Ordinance 02-2019, Series of 2019
Dillon Homewood Suites PUD Development Plan
Major PUD Amendment

Exhibit 'C'
Architectural Review

RSA REVIEW
3/21/18

Lake Dillon Homewood Suites

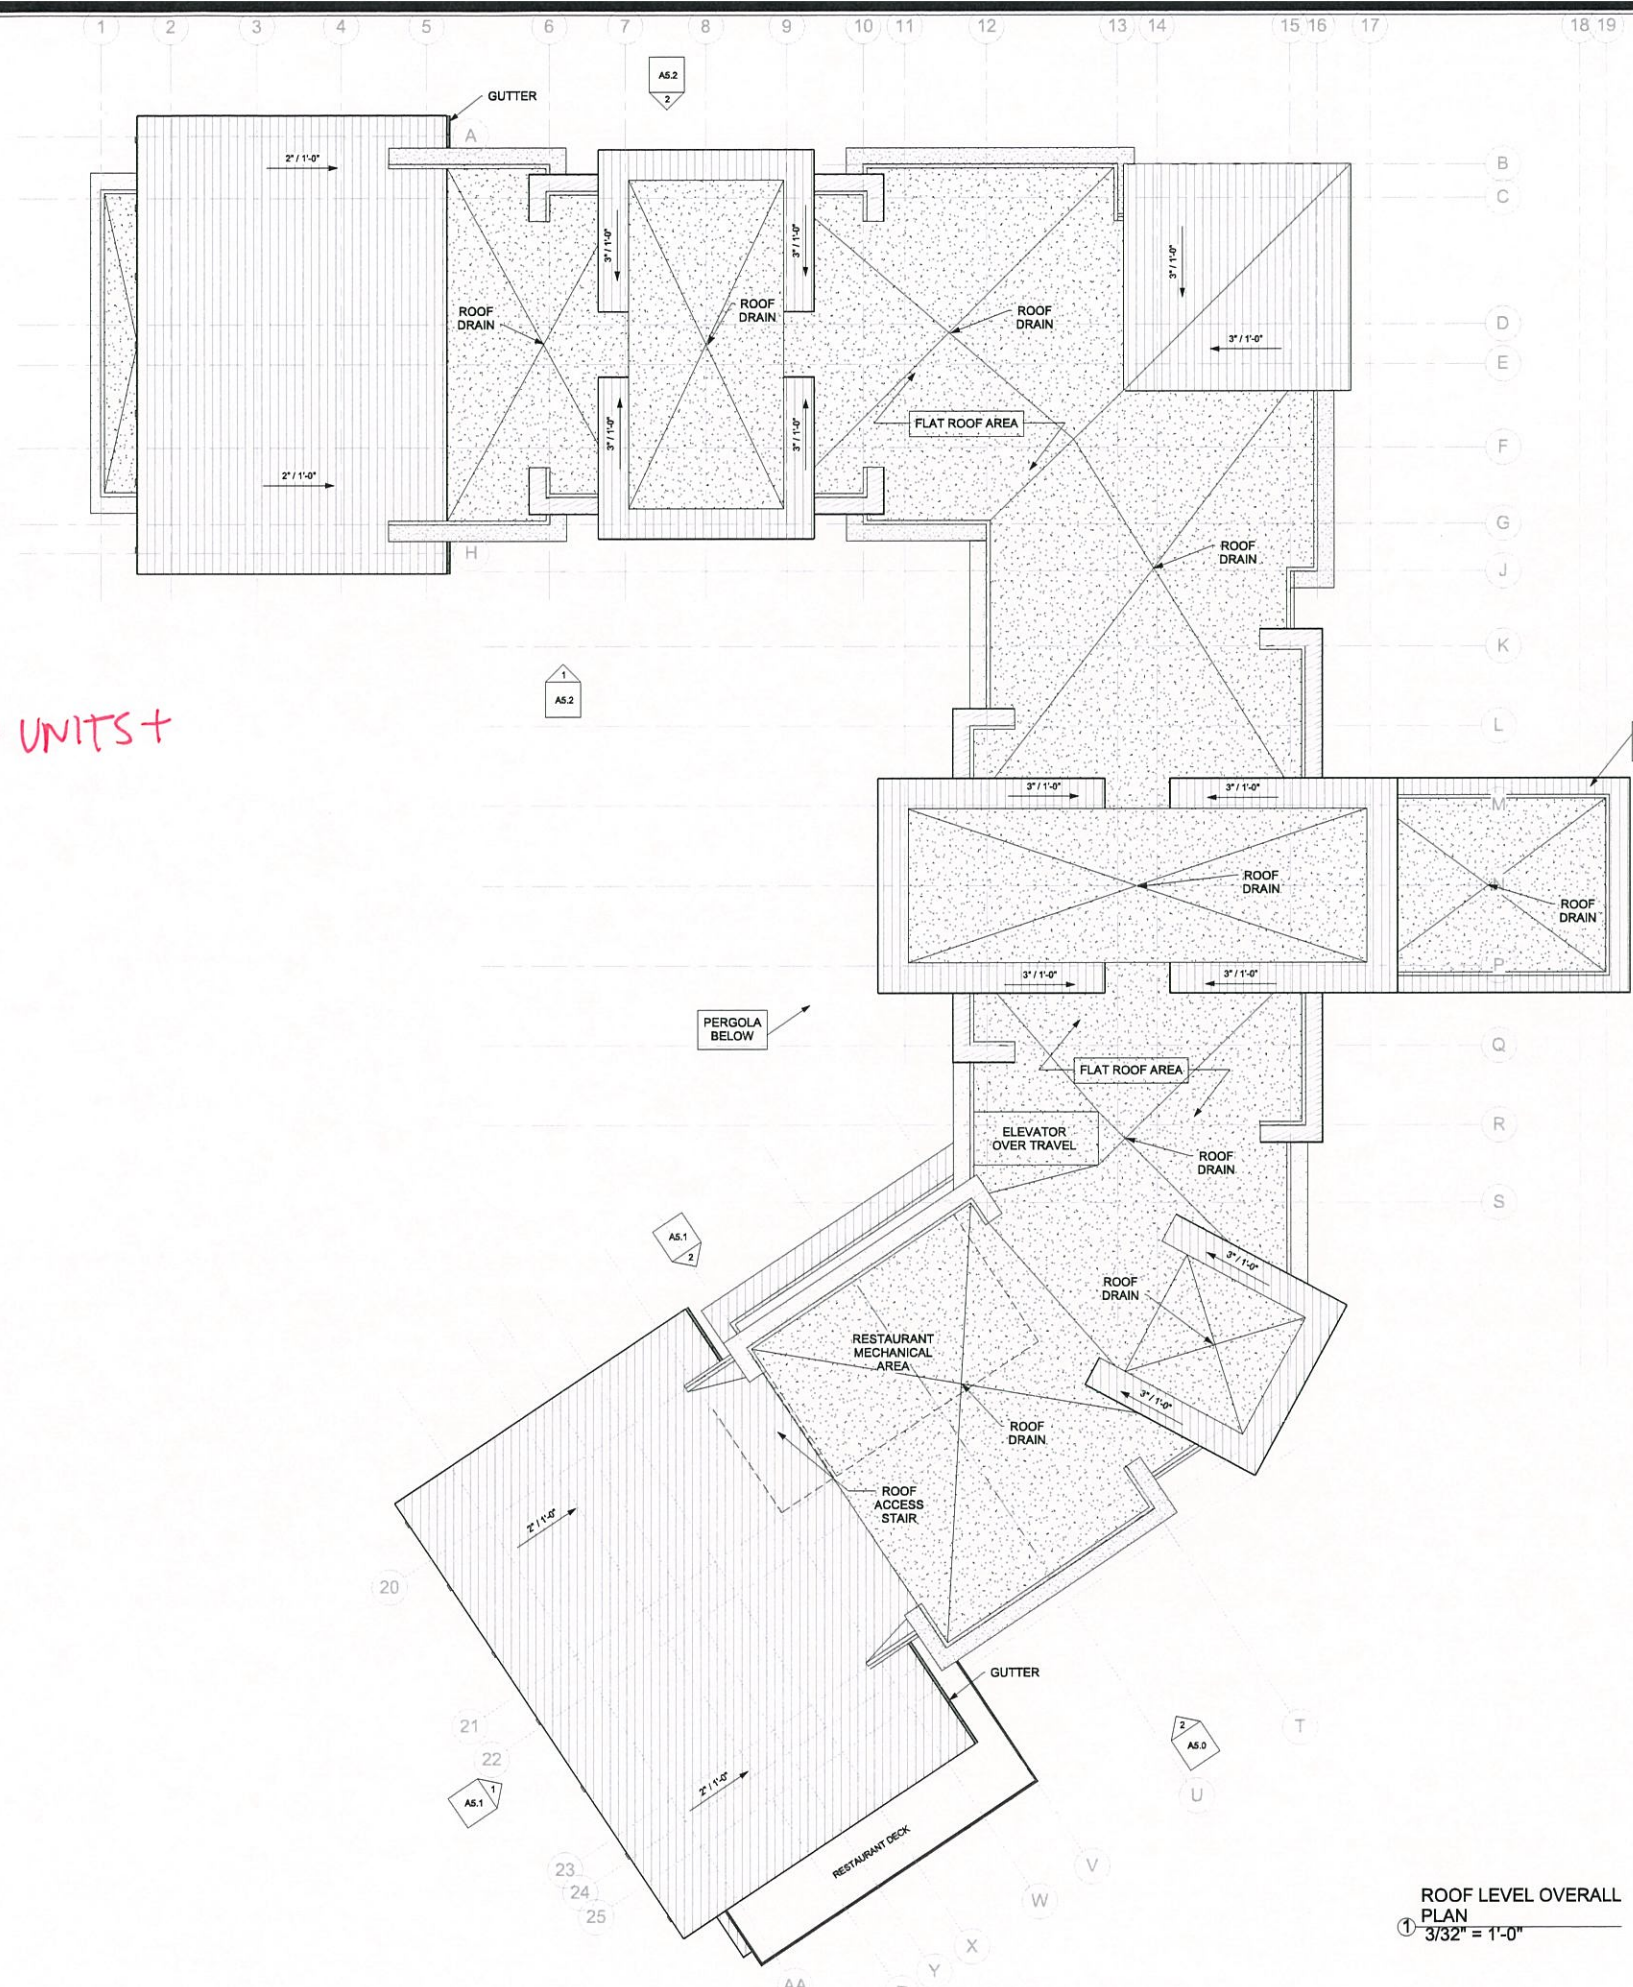
ON PREVIOUS DESIGN HAD A MORE SUCCESSFUL SOLUTION TO THE ROOF WITH A MAJOR ROOF SUPPORTED BY MINOR ROOF FORMS.

PRESENT SOLUTION IS ALL MINOR ROOFS, ALL OF EQUAL IMPORTANCE. DOES NOT MEET DESIGN CRITERIA.
